Rezoning Transportation Analysis

Petition Number: 2017-035

General Location Identifier: 119-064-22, 119-064-23, 119-064-30, 119-063-13

New Bern Transit Station Area Plan

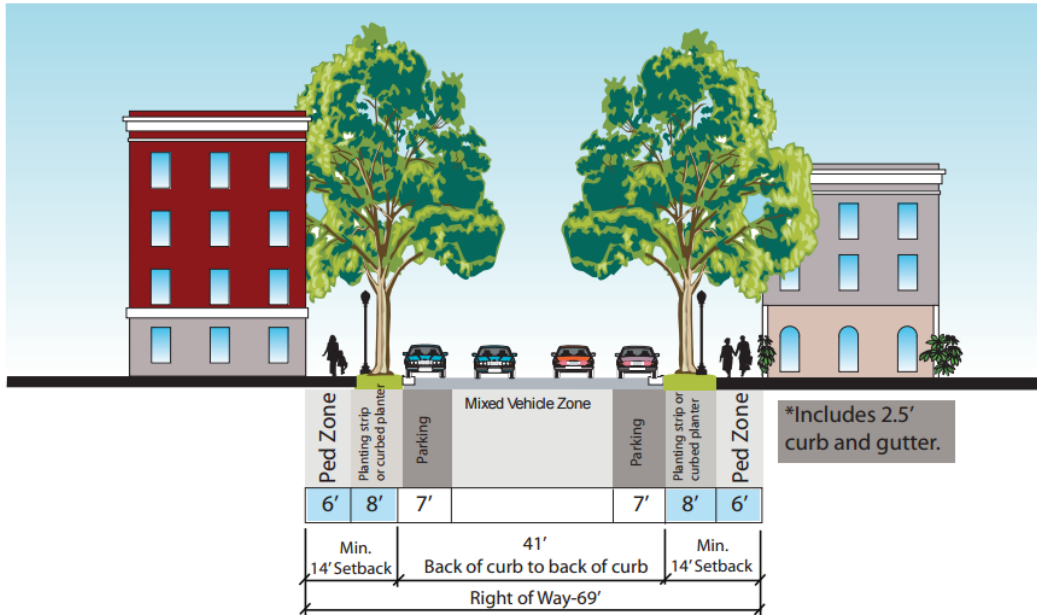
The proposed zoning district has a setback measured from an existing or proposed future curblines. The location of the future curblines per the area plan is 20.50' from existing centerline (see below). However, CDOT is requesting that this curblines take into account a future 7' bike lane. Thus, the future curblines should be placed 27.50' from existing centerline.

1. The petitioner should revise the site plan by relocating the proposed curb 27.50' from the existing centerline of road. This will account for the area plan recommendation in addition to the future bike lane.
